THE NEW W. EDWARD BALMER SCHOOL

NORTHBRIDGE, MASSACHUSETTS

SCHOOL BUILDING COMMITTEE MEETING

APRIL 24, 2019

VE LIST: A04-ITEM 1 OPTION 1

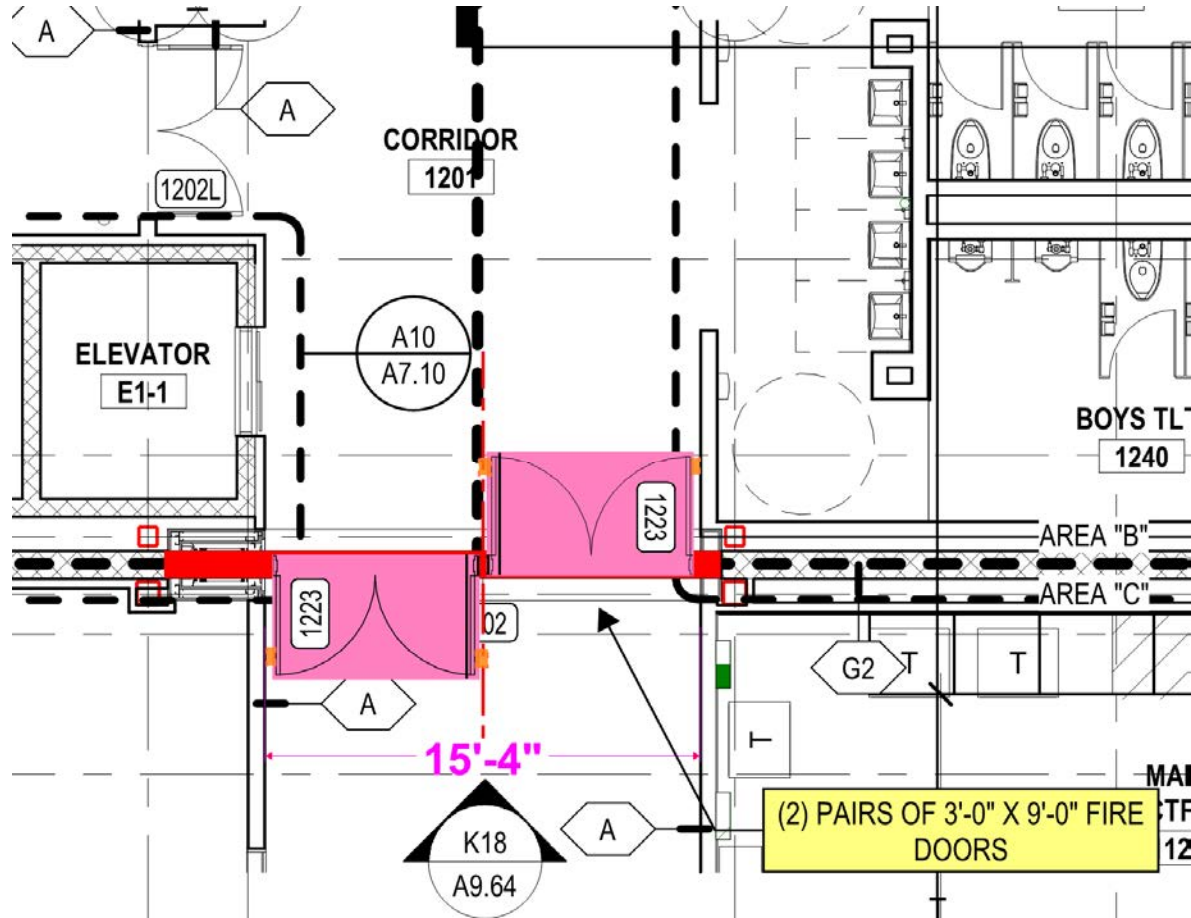
| A04 | Item 19 | Provide swinging full-height fire doors [(2) pairs @ 4' w x 9' tall] ILO "Won-Door" sliding fire door (3 levels) | (\$66,932) |

VE LIST: A01- OWNER'S ITEM 16

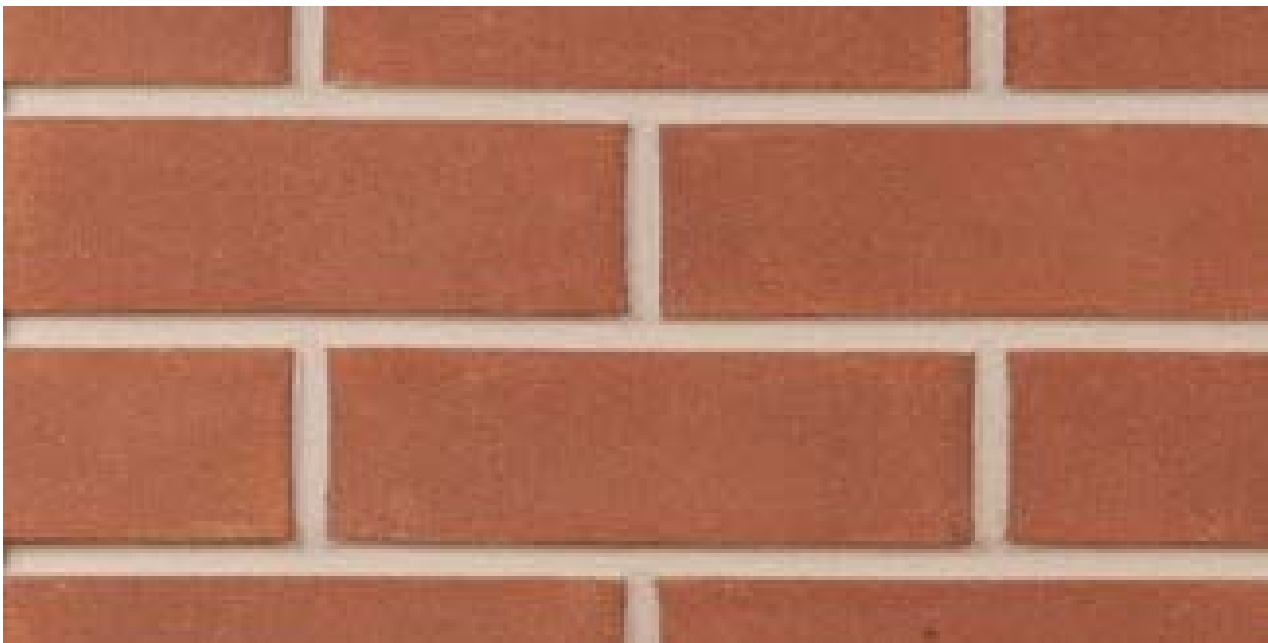
| A01 | A4 dwgs / Item 16 | Provide Utility brick ILO standard Modular brick on entire building. | (\$90,585) |

*Design Team Recommendation:
Keep As designed*

VE LIST: ITEM A13

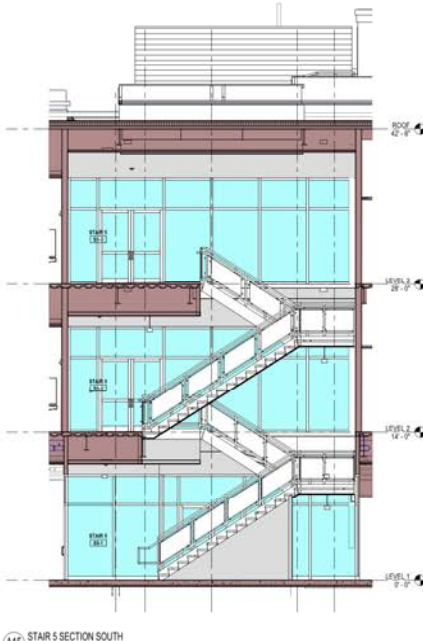
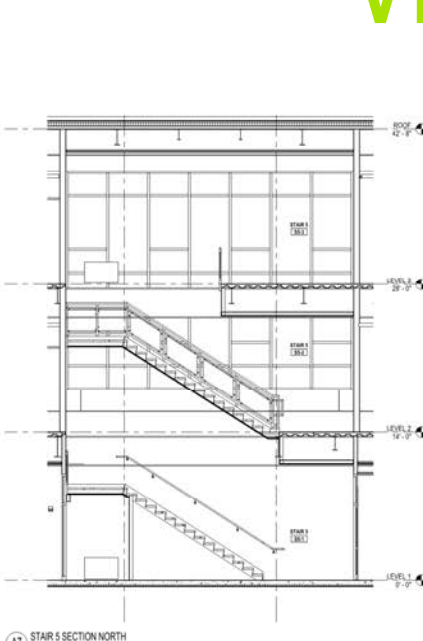
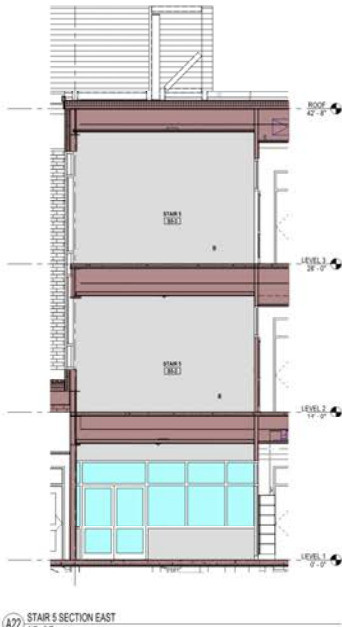
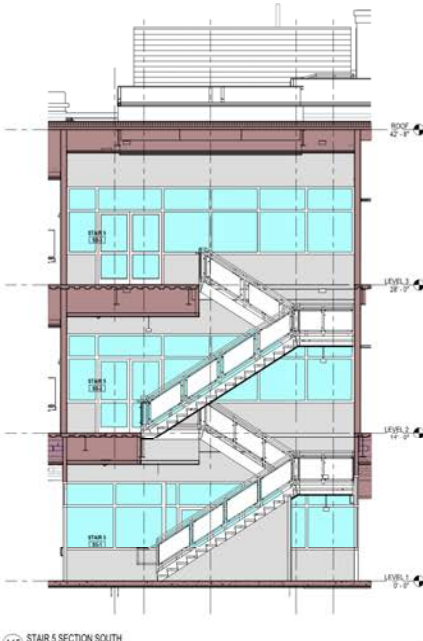
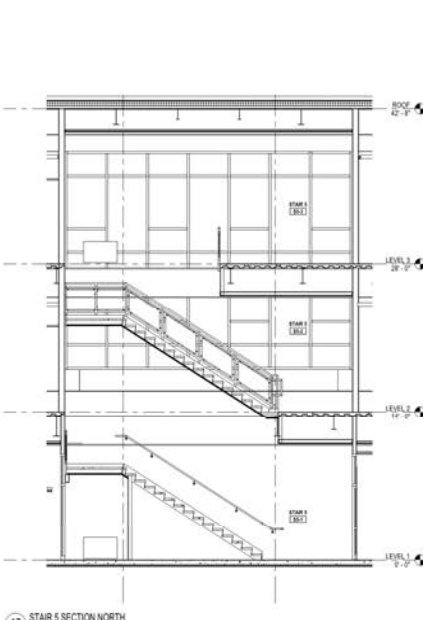
- reduce glazed area by ~25%
- Deduct: \$56,635

- Stair 5 transparency is central design element
- Main communicating stair for full population
- Lightwell at top to disseminates light through deep floor plate – all levels
- Full view to areas of refuge in case of fire

VE LIST: ITEM A12

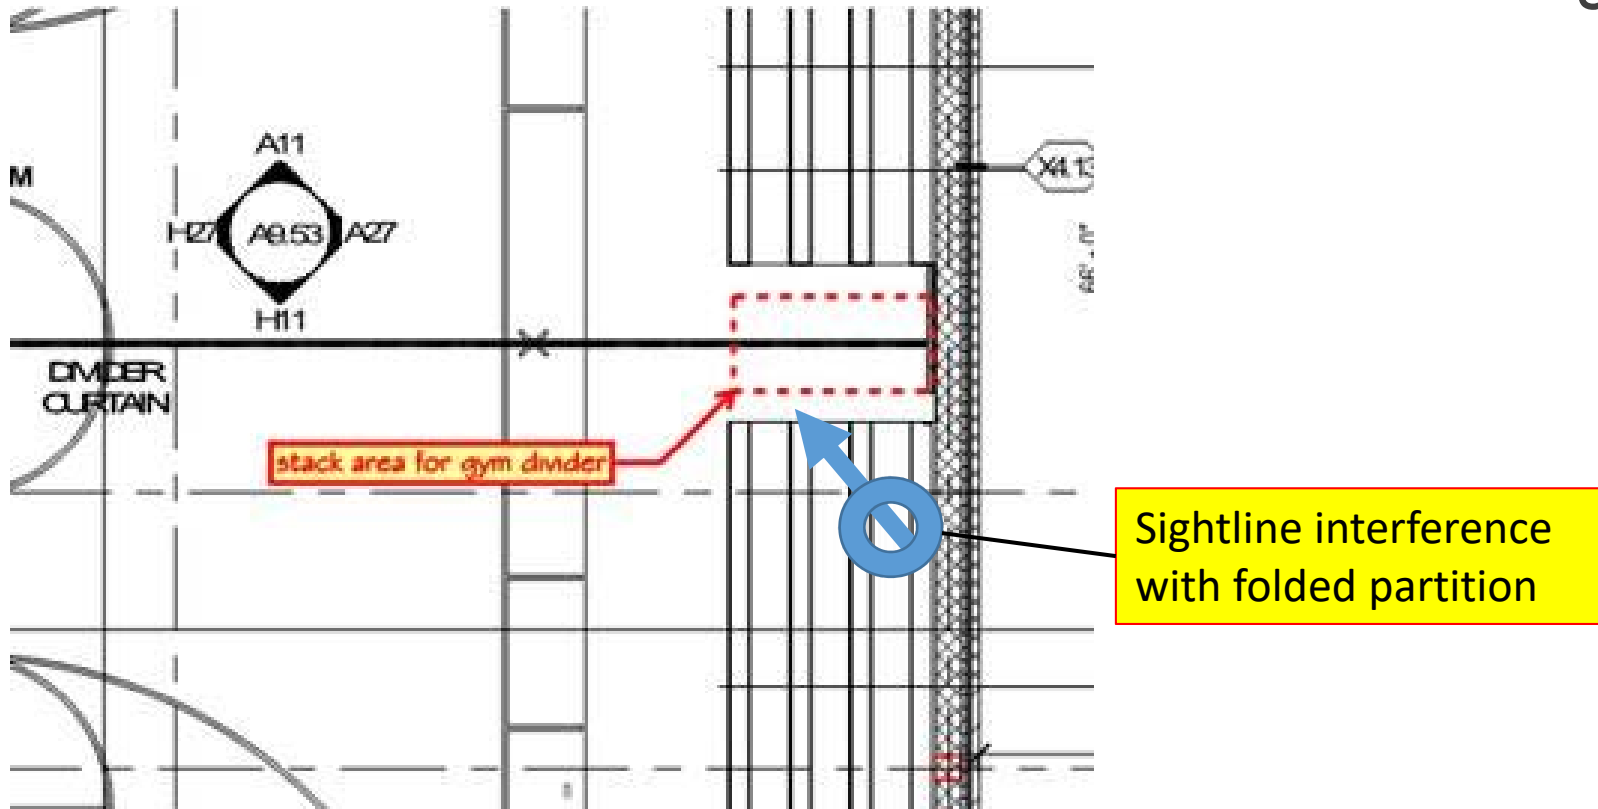
- Previously accepted
- Sight line issues

Provide Operable Partition at Gym

Design Team Recommendation: Good VE application
